Access Compliance Report

Public Rights-of-Way

Intersection ID: 10041624	Main Street: WHITEHALL EXECUTIVE CENTER DR	Cross Street: N/A	Location: NE
ADA ID: 54E121950C23	Ramp Type: Perp	Initial Pass/Fail: Fail	Overall Compliance: No
Codes/Mitigation Info/Possible Solution			Severity Score: 35
			Field Measurements/Component Compliance

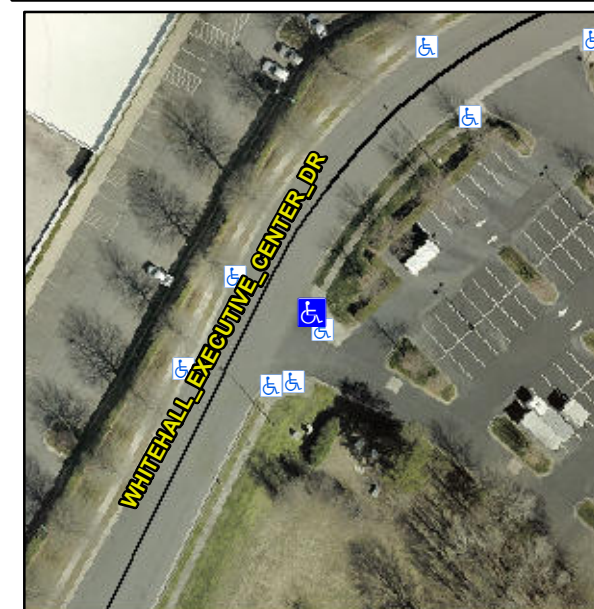
Not Found, R304.5.1

Compliance	Description	Data	Compliance	Description	Data
N/A	Ramp Length (in)	93.0	Yes	Ramp Slope (%)	5.4
No	Ramp Width (in)	24.0	Yes	Ramp XSlope (%)	0.1
N/A	Flare Type LT	N/A	N/A	Flare Type RT	N/A
N/A	Flare Slope LT (%)	N/A	N/A	Flare Slope RT (%)	N/A
N/A	Flare Traversable LT?	N/A	N/A	Flare Traversable RT?	N/A
N/A	Landing Length (in)	N/A	N/A	DWS Provided?	N/A
N/A	Landing Width (in)	N/A	N/A	DWS Contrast?	N/A
N/A	Landing Slope (%)	N/A	N/A	DWS Length (in)	N/A
N/A	Landing X Slope (%)	N/A	N/A	DWS Full Width?	N/A
N/A	Landing Curb? (Y/N)	N/A	N/A	DWS Offset (in)	N/A
N/A	Shared Landing?	N/A			
N/A	Gutter Ponding?	N/A	N/A	Gutter Slope (%)	N/A
N/A	Gutter Lip Ht (in)	N/A	N/A	Gutter X Slope (%)	N/A
N/A	Painted X Walk1?	No	N/A	Painted X Walk2?	N/A
	X Walk 1 Direction	To NW		X Walk 2 Direction	N/A
N/A	X Walk 1 Width (in)	N/A	N/A	X Walk 2 Width (in)	N/A
	X Walk 1 Slope (%)	3.6		X Walk 2 Slope (%)	N/A
	X Walk 1 X Slope (%)	0.9		X Walk 2 X Slope (%)	N/A

Remove & Replace Entire Ramp.
